IMPORTANT SAFETY RECALL

Safety Notice**SN-658**

SUBJECT: *GFI circuit breakers on 408 volt Hy-Power[™] units***Issue:**

Safety Notice SN658

Figure A

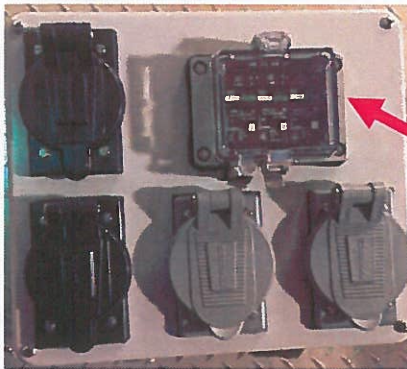
1. Immediately inspect your unit by locating the export power box as shown in Figure A and inspect the circuit breakers as shown in Figure B to determine the manufacturer of the circuit breakers. Only export power boxes that contain **CBi** manufactured circuit breakers are subject to this bulletin and must be replaced.

1. Do not use the export power supply, shown in Figure A, until the GFI is inspected and replaced as necessary.
2. Open breakers shown in Figure B and Lock-Out-Tag-Out the affected export power box circuit breaker cover per your company's procedure.
3. Follow all maintenance and inspection requirements specified in the manuals.

2. Once the inspection is complete and CBi circuit breakers are identified, contact your local Terex authorized dealer.
3. Follow the Continued Use instructions in this bulletin.
4. Terex recommends you complete the replacement as soon as possible, no later than 60 days from receipt of this bulletin.
5. After replacement is complete, fill out the completion form enclosed with the owner letter and return it to the Terex Utilities Warranty Department at utilities.warranty@terex.com or fax to 1-605-882-5579.

Figure B

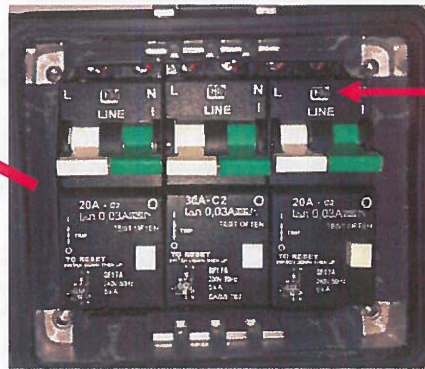
**CBi
Manufacturer
Label**
